Access Compliance Report

Public Rights-of-Way

Intersection ID: 14469	Main Street: E_MOREHEAD_ST	Cross Street: KENILWORTH_AV	Location:	N
ADA ID: 950CF790E105	Ramp Type: PerpDiag	Initial Pass/Fail: Fail	Overall Compliance: No	Severity Score: 25
Codes/Mitigation Info/Possible Solution		Field Measurements/Component Compliance

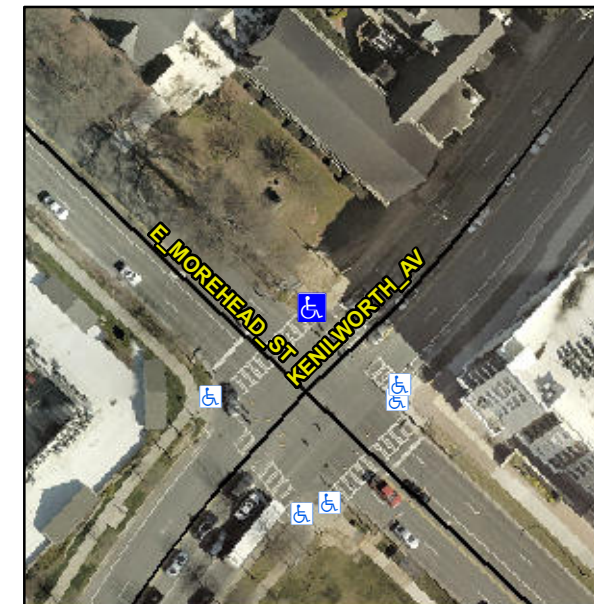
Not Found, R304.2.2, R304.5.3

Compliance	Description	Data	Compliance	Description	Data
N/A	Ramp Length (in)	62.0	No	Ramp Slope (%)	11.3
Yes	Ramp Width (in)	55.0	No	Ramp XSlope (%)	5.4
N/A	Flare Type LT	N/A	N/A	Flare Type RT	N/A
N/A	Flare Slope LT (%)	N/A	N/A	Flare Slope RT (%)	N/A
N/A	Flare Traversable LT?	N/A	N/A	Flare Traversable RT?	N/A
N/A	Landing Length (in)	N/A	N/A	DWS Provided?	N/A
N/A	Landing Width (in)	N/A	N/A	DWS Contrast?	N/A
N/A	Landing Slope (%)	N/A	N/A	DWS Length (in)	N/A
N/A	Landing X Slope (%)	N/A	N/A	DWS Full Width?	N/A
N/A	Landing Curb? (Y/N)	N/A	N/A	DWS Offset (in)	N/A
N/A	Shared Landing?	N/A			
N/A	Gutter Ponding?	N/A	N/A	Gutter Slope (%)	N/A
N/A	Gutter Lip Ht (in)	N/A	N/A	Gutter X Slope (%)	N/A
N/A	Painted X Walk1?	Yes	N/A	Painted X Walk2?	Yes
	X Walk 1 Direction	To SW		X Walk 2 Direction	To SE
N/A	X Walk 1 Width (in)	108.0	N/A	X Walk 2 Width (in)	112.0
	X Walk 1 Slope (%)	5.3		X Walk 2 Slope (%)	1.4
	X Walk 1 X Slope (%)	1.3		X Walk 2 X Slope (%)	4.7

Remove & Replace Curb Ramp With Two New Directional Ramps or Equivalent.
